SUBJECT: Forwards response to 980413 RAI re TS change 95-03,
 addressing newly installed MSLB protection circuitry.

Subject: Oconee Nuclear Station
Docket Nos. 50-269, -270, -287
Proposed Revision to Technical Specifications
Technical Specification Change # 95-03
Response to Request for Additional Information #3

RESPONSE TO REQUEST FOR ADDITIONAL INFORMATION

Figure 1
Oconee Steam Line Break With Continued MFW Addition: Containment Pressure

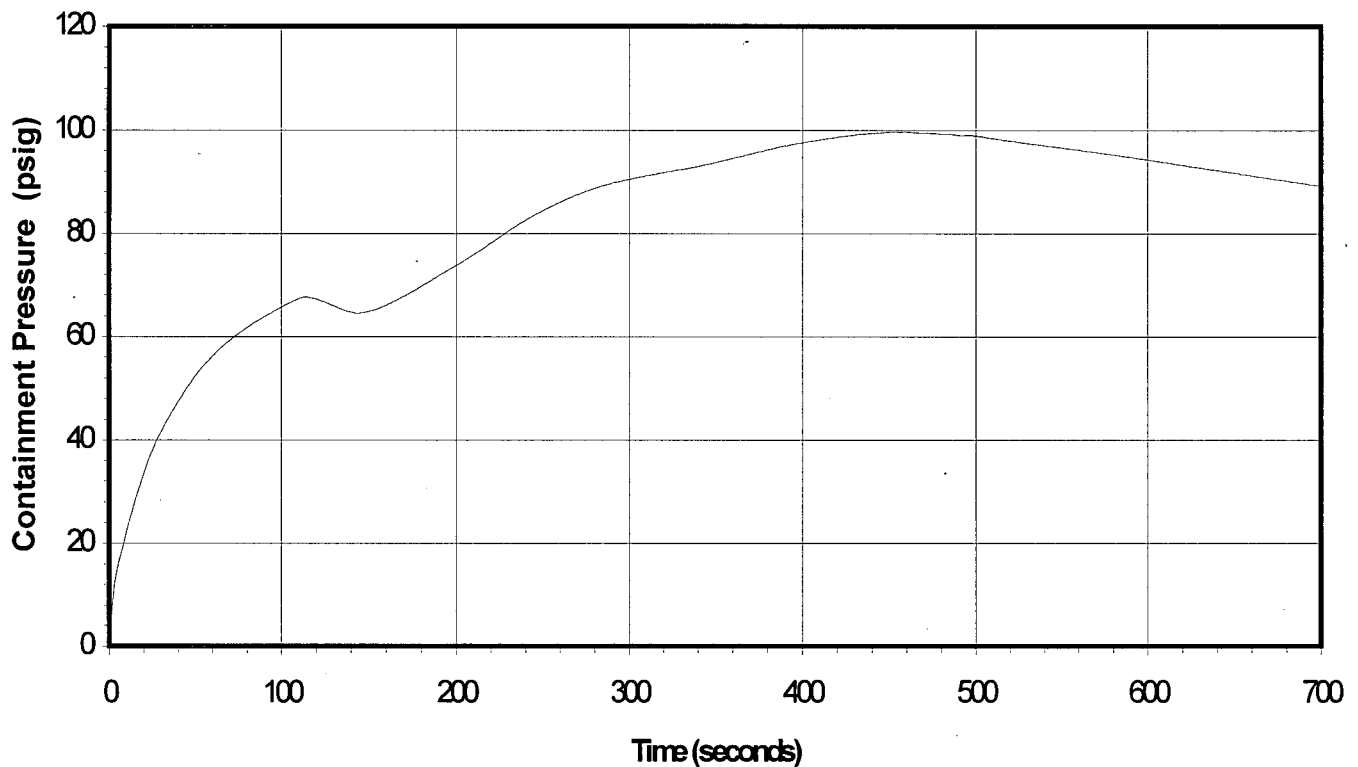
Provide the results of a containment analysis (as requested by Bulletin 80-04) that reflects the actual design of the MFW isolation capability at Oconee. The analysis should assume that feedwater continues to be added to the faulted steam generator (via the condensate pumps) for ten minutes (assumed for operator action to secure flow) or for the time it takes to isolate MFW flow via the MFW block valves if they can close under the differential pressure associated with the condensate pumps. The analysis can take credit for all containment cooling features, since no other single failures need be assumed. The analysis should also assume that offsite power is available since the condensate pumps would not be running for a loss of offsite power.

An analysis was performed for a main steam line break (MSLB) with continued feedwater addition to the faulted steam generator via the condensate booster pumps for ten minutes due to the failure of the main feedwater (MFW) control valve to close. The MFW block valves are assumed to be unable to close under the differential pressure associated with the condensate pumps. It is assumed that the MSLB Detection and Feedwater Isolation System functions to trip the MFW pumps and the turbine-driven emergency feedwater (EFW) pump, and to close the MFW control valve to the unaffected steam generator. Since a failure of the MFW control valve to the affected steam generator is assumed, no other single failure is postulated. Thus, two trains of high pressure injection (HPI) are credited and the EFW flowrate is controlled to maintain steam generator level at the control setpoint. Credit is taken in the analysis for all containment cooling features. Offsite power remains available.

Break flow decreases steadily as the containment backpressure approaches the pressure in the affected steam generator. At 500 seconds, the hot leg temperature of the affected loop decreases below the saturation temperature corresponding to the pressure in the steam generator. Thus, no steam is released after this point and the break enthalpy decreases to that of a liquid release. By 510 seconds, the steam line between the affected steam generator and the break location is filled with liquid. Thus, a substantial amount of liquid break flow continues that is essentially equal to the rate of main feedwater addition by the condensate booster pumps. The transient simulation is terminated at 700 seconds.

The methodology used to perform the FATHOMS containment analysis is detailed in topical report DPC-NE-3003-PA, "Mass and Energy Release and Containment Response Methodology." Three reactor building cooling units (RBCUs) and two spray trains are assumed to be available. The RBCU actuation signal occurs at 2 seconds, and the units are running at 80 seconds. The containment spray actuation signal occurs at 17 seconds, and the spray flow starts at 109 seconds. Containment pressure increases steadily until the peak containment pressure (Figure 1) of 100 psig is reached at 445 seconds. The containment pressurization is terminated by the decreasing break flowrate as well as the change in the break flow from steam to liquid. The simulation is run for 700 seconds.

Duke performed a containment analysis to allow the NRC staff to assess the design of the MFW isolation capability at Oconee. The analysis assumed that feedwater continued to be added to the faulted steam generator, via the condensate pumps, for ten minutes. The analysis took credit for all containment cooling features since no other single failures were assumed. The analysis also assumed that offsite power was available. The analysis indicated that a peak reactor building pressure of 100 psig is reached at 445 seconds into the accident simulation. The containment temperature exceeded the equipment qualification limit during the 700 second transient simulation. However, this requested analysis is considered to be outside Oconee's current licensing basis. UFSAR Chapter 6 describes Oconee's current limiting MSLB analysis with respect to containment temperature and pressure.
